UNITED STATES PATENT AND TRADEMARK OFFICE

Office Action Summary

10/071,726

MORITZ ET AL.

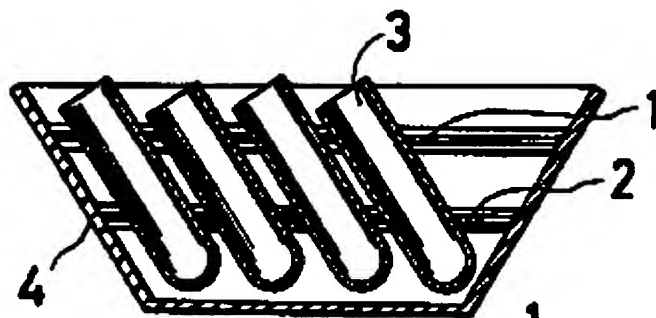
Iizuka et al. discloses tube holder in which the angle at which the tubes are held is variable, and a box reservoir in which the above holder with the tubes can be laid.

The tube holder is preferably constituted by upper panel 1 (face having a plurality of seats) and lower panel 2 which have means to hold each tube in the usual manner and which can be slid horizontally. (column 1, lines 40-42).

Variable angle tube holder used in this invention may be made of glass, metals, plastics **or composite of these materials**. The upper and lower panels may be a plate with holes which can hold tubes, or a composite of wires or sticks. (column 2, lines 40-44)

As seen in the figure above sidewall (4) depends downward from face 1.

litzka it al does not specifically describe the holder as being comprised of an electrically conductive plastic.
